UNITED STATES
DEPARTMENT OF THE INTERIOR
BUREAU OF LAND MANAGEMENT

FORM APPROVED
OMB NO. 1004-0135
Expires: July 31, 2010**SUNDRY NOTICES AND REPORTS ON WELLS**
*Do not use this form for proposals to drill or to re-enter an abandoned well. Use form 3160-3 (APD) for such proposals.***SUBMIT IN TRIPLICATE - Other instructions on reverse side.**

**COG Operating LLC
NMNM14840
White Star Federal 20
30-015-32247
Section 29, T. 17 S., R 29 E., NMPM
Eddy County, New Mexico**

White Star #20 DEEPENING PROGRAM

CENTRALIZED
INTERCASING

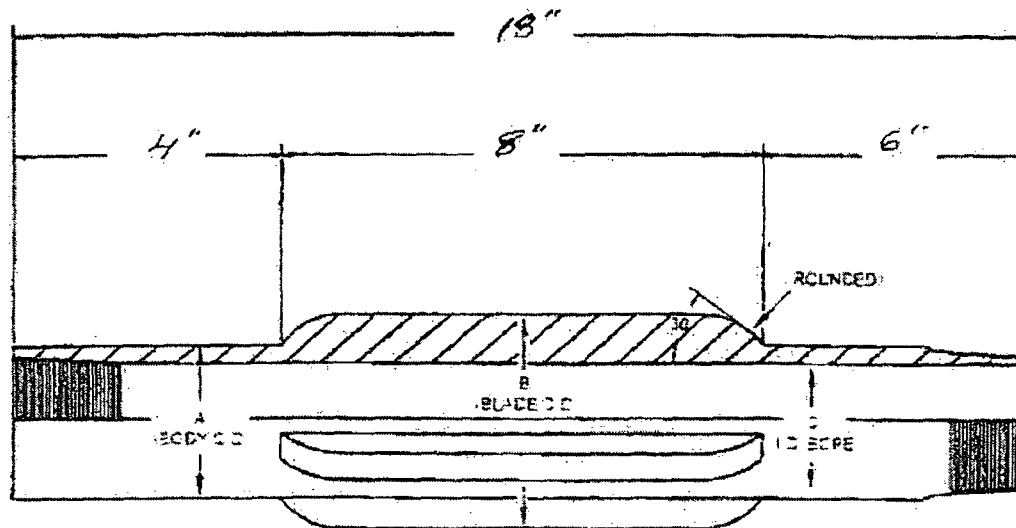
NOTE: COG OPERATING LLC REQUESTS A VARIANCE TO THE 0.422" STAND OFF RULE BETWEEN CASING AND WELLBORE.

Fixed blade stabilizer subs will be utilized in the casing string to insure adequate isolation and seal throughout the wellbore. These stabilizer subs are positive fixed blade type. These subs will actually be screwed into the casing string. A diagram of the fixed blade stabilizer sub is located at the end of this program.

- 5. BOP to be tested to 1000 psi based on expected BHP**
- 6. Variance for stand-off of less than 0.422" is approved due to NMOCD classifying the formations in this area as the Yeso group - Pool 96610.**

- 5. BOP to be tested to 1000 psi based on expected BHP**
- 6. Variance for stand-off of less than 0.422" is approved due to NMOCD classifying the formations in this area as the Yeso group - Pool 96610.**
